from
**Southern
Water**

Your ref
AL/85/21/PL

Our ref
PLAN-040417

Proposal: Subdivision of existing building to create 2 bedroom dwelling, construction of detached garage/workshop, external & boundary works. This application affects the setting of a listed building, affects the Norton Lane/Norton Conservation Area & is in CIL Zone 3 & CIL Liable as new dwelling.
Site: AL/85/21/PL: - Norton Farm House, Norton Lane, Norton, PO20 3NH.

ARUN DISTRICT COUNCIL AL/85/21/PL

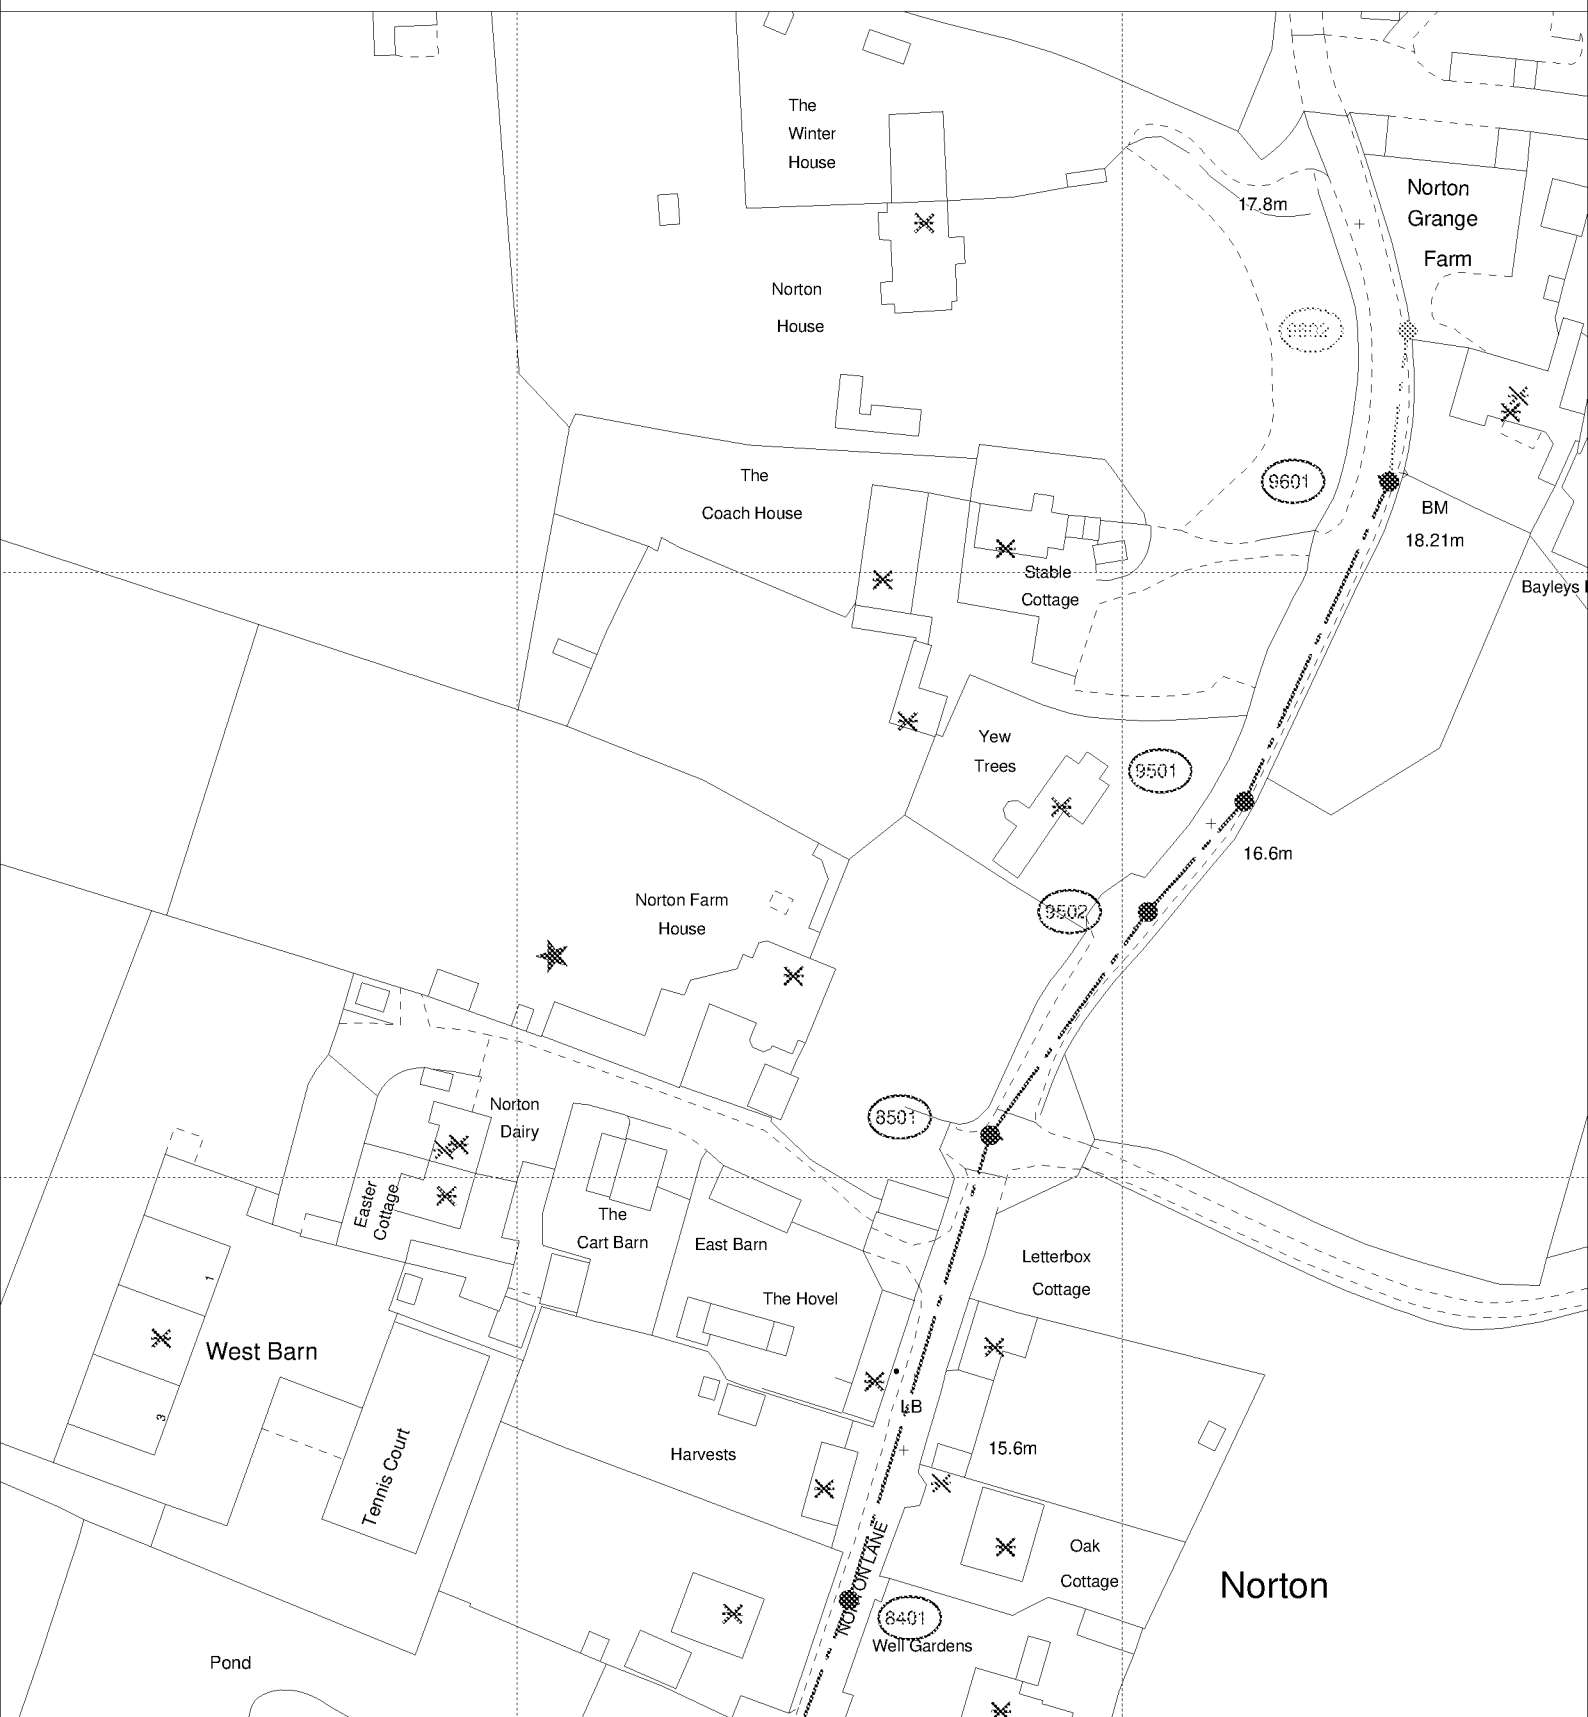
It is possible that a sewer now deemed to be public could be crossing the development site. Therefore, should any sewer be found during construction works, an investigation of the sewer will be required to ascertain its ownership before any further works commence on site.
